# **January 2011 Flood Event: Report on the operation of Somerset Dam and Wivenhoe Dam**

## **REVIEW OF HYDROLOGICAL ISSUES**

- Final A
- 11 March 2011

Sinclair Knight Merz  
ABN 37 001 024 095  
Floor 11, 452 Flinders Street  
Melbourne VIC 3000  
PO Box 312, Flinders Lane  
Melbourne VIC 3000 Australia  
Tel: +61 3 8668 3000  
Fax: +61 3 8668 3001  
Web: [www.skmconsulting.com](http://www.skmconsulting.com)

Figure 2.1 Estimates of rainfall totals to 8:00am 11 January 2011 (sourced from [www.bom.gov.au](http://www.bom.gov.au) during the event).

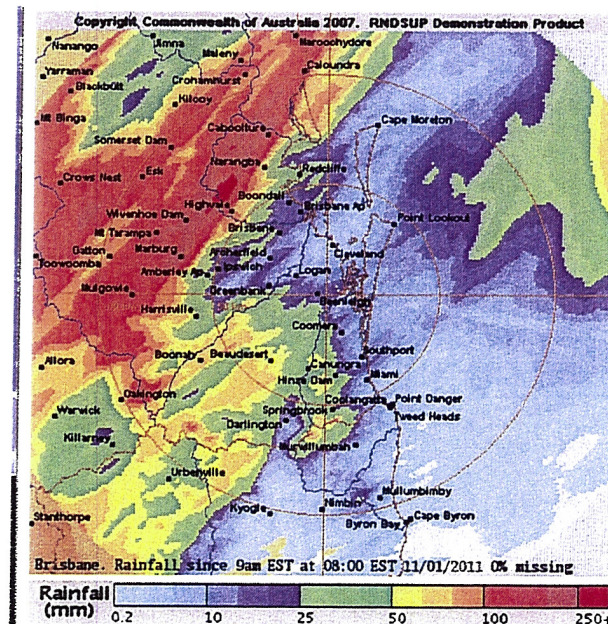
From radar imaging available during the event and inferences from the water level data in Wivenhoe Reservoir, it is believed there was substantial rainfall in the vicinity of the reservoir on the morning of 11 January that was not reflected in the telemetered data. It is understood that additional rainfall stations are being installed which will increase the density of rainfall coverage, however there will always be the possibility that significant rainfall may occur between stations. Inevitable gaps in the rainfall networks can be mitigated by incorporating information from weather radar during an event. For example, Figure 2.1 shows the 24 hour rainfall depths to 8:00am

on 11 January 2011 estimated from the weather radar operated by the Bureau of Meteorology. This image was captured from the Bureau of Meteorology web site during the event and does not reflect the outcome of any quality control measures and verification against recorded point rainfalls that may have occurred subsequently. The radar image shows the high rainfalls in the vicinity of the Wivenhoe Reservoir that were not captured by the ALERT gauges. Although there still remains uncertainty in radar rainfall estimates, such information (as discussed in Section 8.9 of the Seqwater report) can be used in at least a qualitative manner to help inform the interpolation between point estimates of rainfall.

**Figure 4.1 Comparison of eight day rainfall totals recorded by Seqwater and Bureau of Meteorology gauges to 13 January 2011.**

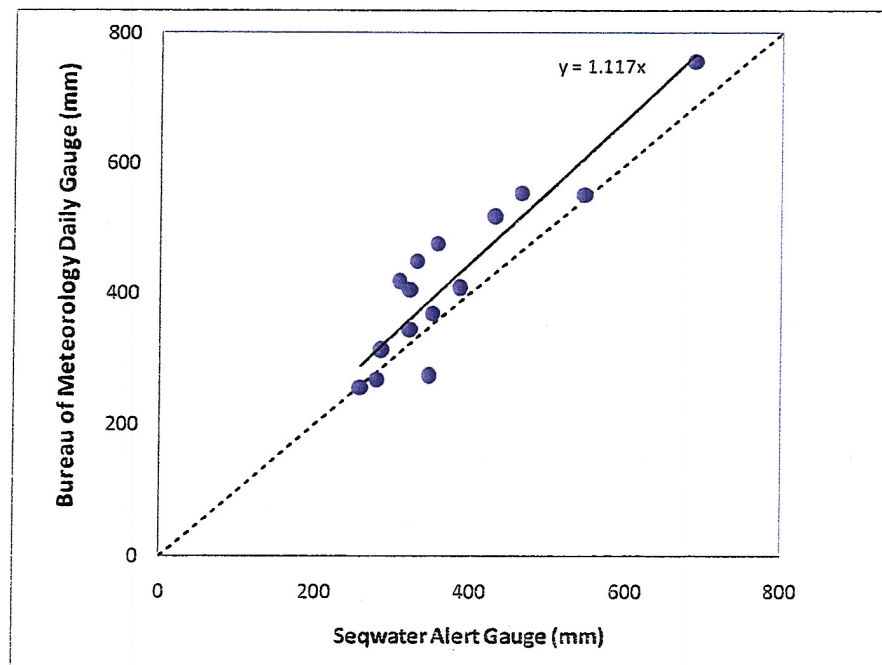
Figure 4.1 below shows that there is generally good agreement in the rainfall totals at the pairs of stations. There appears to be a small bias with the daily read values approximately 10% higher than the ALERT values. The reason for this relatively small bias was not explored but could possibly be attributed to the tendency for the ALERT gauges in the lower rainfall portions of the catchment. However, given the close proximity of the station pairs the difference it is speculated that the most likely reason for the bias might be due to differences in standard installation details (such as distance from the ground and exposure of the site).

The generally good agreement between the ALERT and daily read data confirms that the ALERT data is appropriate to support flood operations decision making in real time. In real time the tendency of the ALERT data to slightly underestimate the rainfall totals when compared to the daily gauges is compensated by the progressive calibration of the loss model during the event, and by closing the water balance at the reservoir itself.

**Figure 4.2 Progressive comparison of 24 hour catchment average Quantitative Precipitation Forecasts versus actual values.**

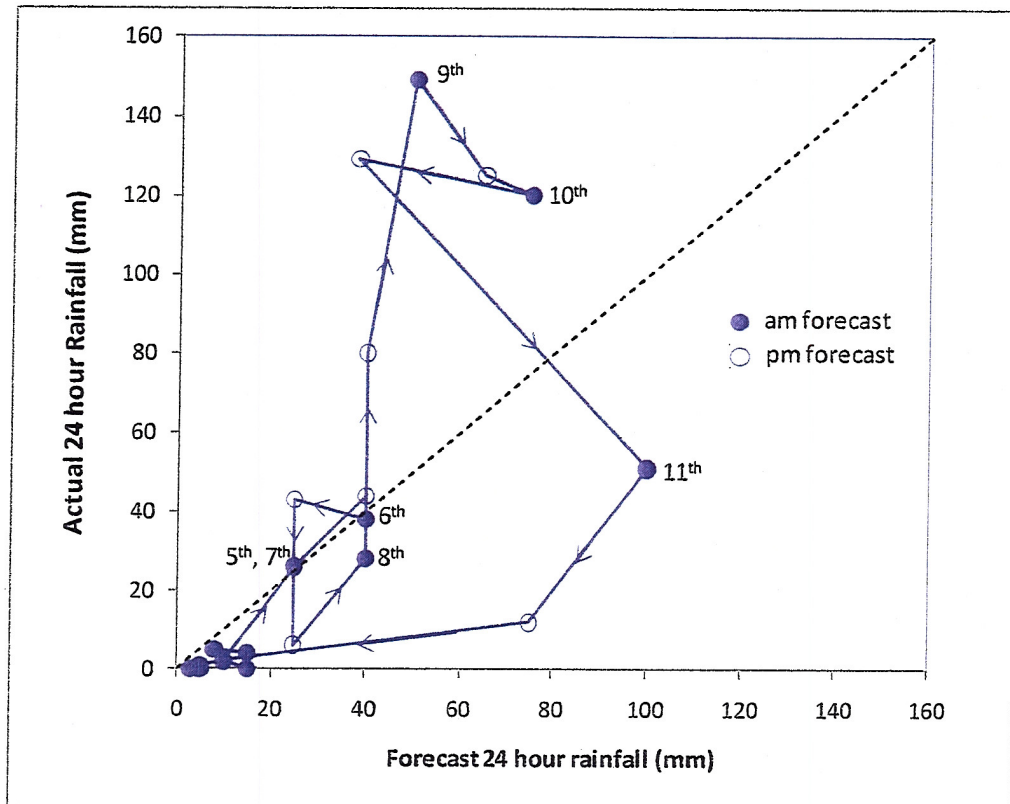
The performance of the 24 hour catchment average Quantitative Precipitation Forecasts provided by the Bureau of Meteorology is illustrated graphically in Figure 4.2. It is seen that the forecasts leading into the first and second major flood peaks (morning of the 9<sup>th</sup> and afternoon of the 10<sup>th</sup>) were around one third the actual. The forecast following the second peak (on the 11<sup>th</sup>) were around twice the actual.

**Figure 4.3 Progressive comparison of forecast versus actual 24 hour spatial rainfall distribution.**

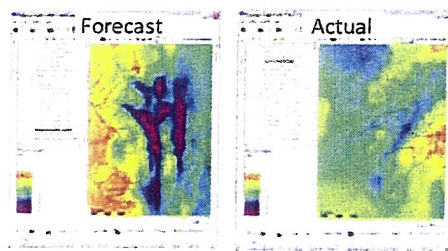
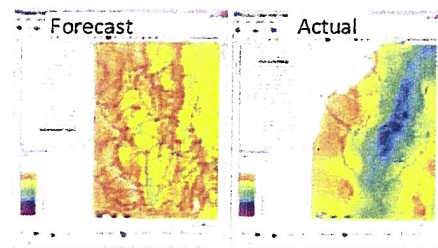
In terms of spatial accuracy, it is seen in Figure 4.3 (from Seqwater Appendix J) that the 24 hour forecast made at 9am on the 10<sup>th</sup> does indicate very heavy rainfall over the Stanley catchment and in the immediate vicinity of Wivenhoe Dam. However the 24 hour forecasts for 9am on the 11<sup>th</sup> does not pick up the heavy rain in the immediate vicinity of Wivenhoe (which supports the inference discussed in the previous section regarding the sharp rise in reservoir level).

**Figure 4.3 Progressive comparison of forecast versus actual 3-day and 5-day rainfall totals.**

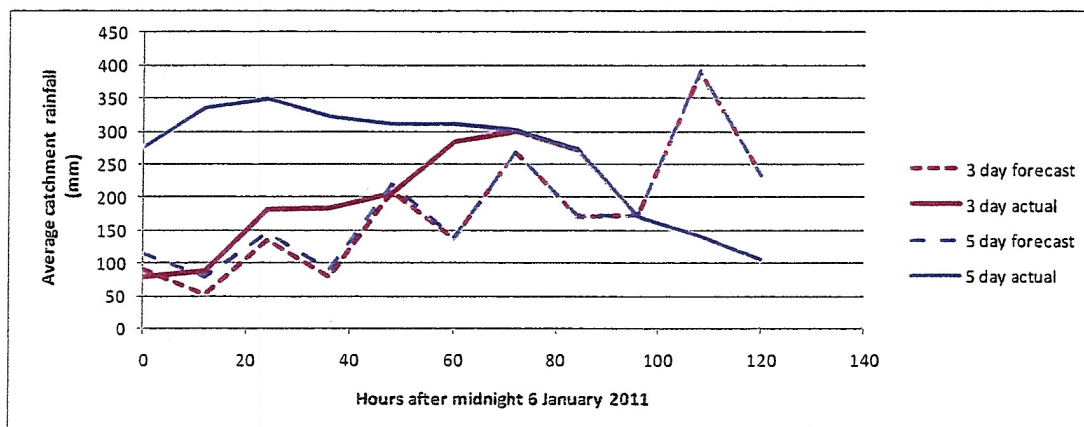
Figure 4.3 also highlights two features of particular interest:

- The difference between the 3-day and 5-day ACCESS forecasts is negligible throughout the event, which indicates that the rainfall was always expected to fall predominately within a 72-hour period; and,
- The successive forecasts fluctuate around a mean trend prediction by an alternating divergence of around 30% – there is little apparent persistence between successive forecasts which is not consistent with physical reasoning.

Figure 4.4 Forecast streamflows undertaken at 7pm on the 9<sup>th</sup> and 4am on the 11<sup>th</sup> January.

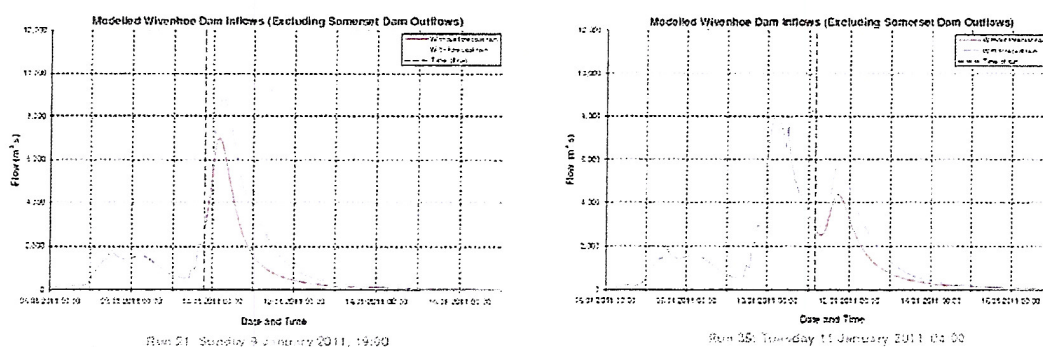
With respect to Run 21, the model predicted an inflow peak of around 8,800 m<sup>3</sup>/s, which is only about 5% lower than the computed peak (Table in Section 9 of the Seqwater report); the timing of the peak was correctly forecast to be some 12 hours later. It is assumed that the forecast was made using the 24 hour rainfall forecast that was around 50% lower than what actually occurred.

With respect to Run 35, the model predicted the second inflow peak of around 6,000 m<sup>3</sup>/s, which is around 55% lower than the computed peak; the timing of the peak was forecast to be some 14 hours later, which is a little later than what actually occurred. It is worth noting that the streamflow forecast was made when the previous 24 hour rainfall forecast was around 30% less than what actually occurred.

It is hard to see how these forecasts could be improved upon. In both cases the streamflow gauges further upstream in the catchment had only just commenced to rise again after the previous flood recession. The model is integrating the upstream flows that were recorded and routing them downstream to the reservoir, and there is insufficient forecast rainfall to magnify the flood response.

**Figure 5.1 Spatial analysis of exceedance probabilities of 48 hour rainfalls.**

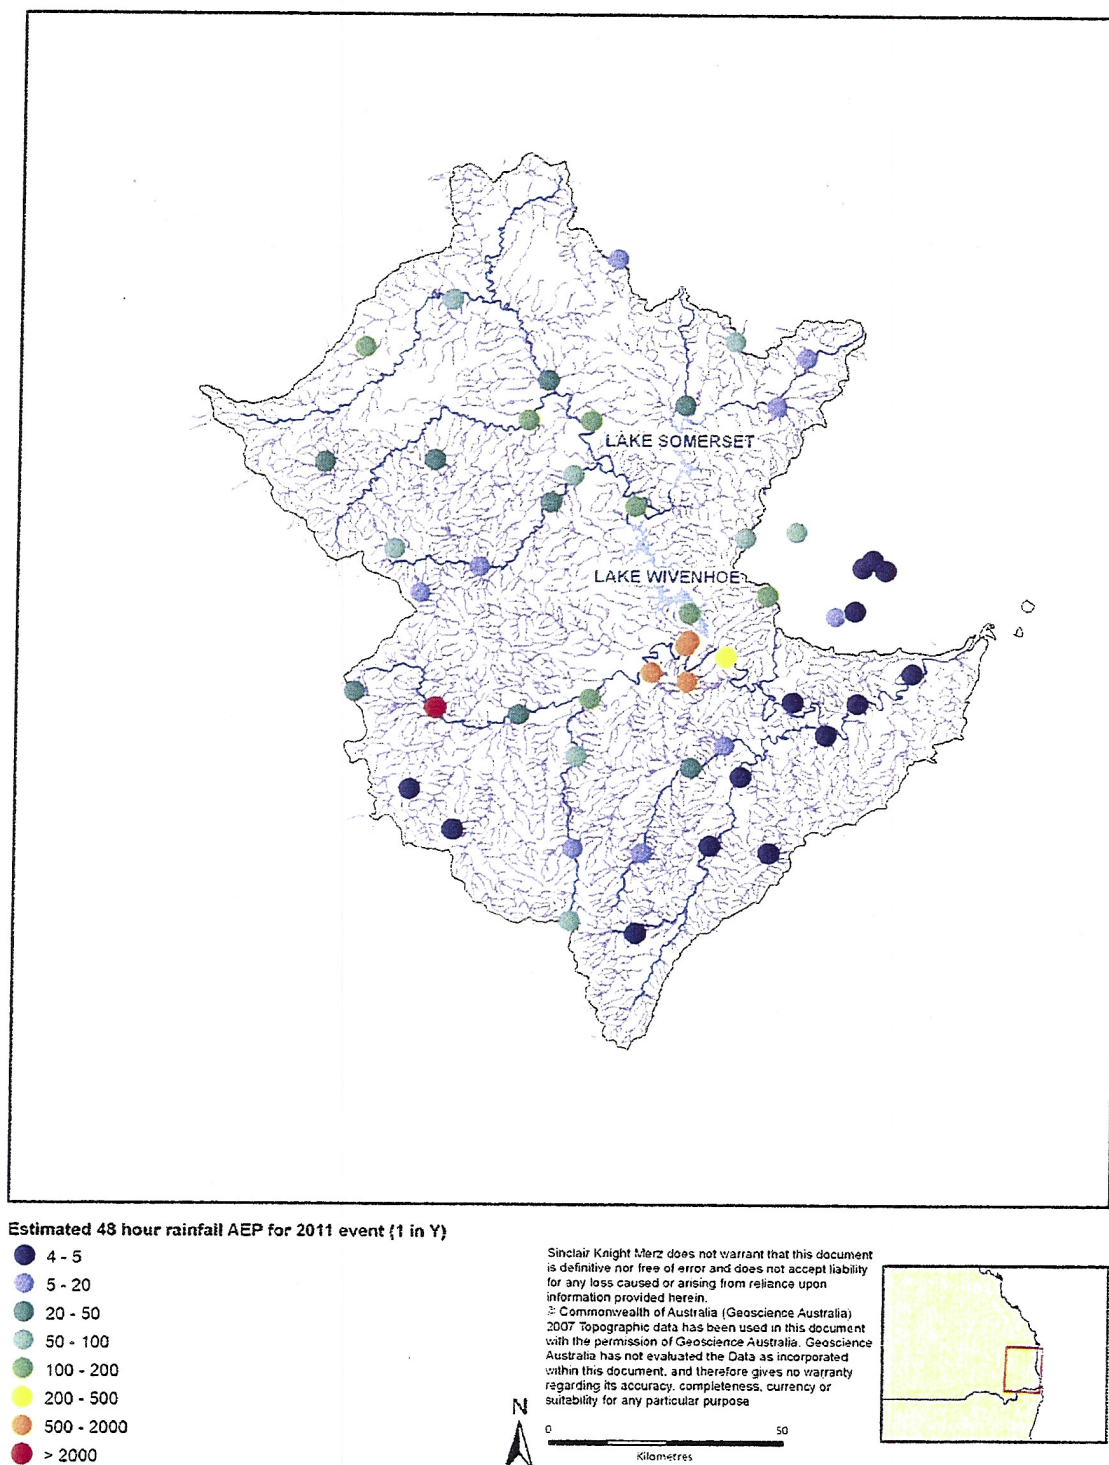
On the basis of Figure 5.1 it may be inferred that:

- The most extreme point rainfalls occurred in the centre of the Brisbane River catchment, in the areas immediately below Wivenhoe Dam – the annual exceedance probability of these rainfalls are between 1 in 500 and 1 in 2000;
- The annual exceedance probability of point rainfalls varies between around 1 in 20 at the upper reaches of the catchment above Wivenhoe Dam, to beyond 1 in 100<sup>+</sup> in the lower reaches; and,
- The most intense region of localised rainfall occurred in the headwaters of the Lockyer Valley.

The above information is consistent with the exceedance probabilities of the catchment average rainfalls presented in Figure 8.4.2 of the Seqwater report (as derived using CRC-FORGE information). On this basis, it seems reasonable to assume that the annual exceedance probability of the catchment average rainfalls upstream of Wivenhoe Dam is between 1 in 100 and 1 in 200.
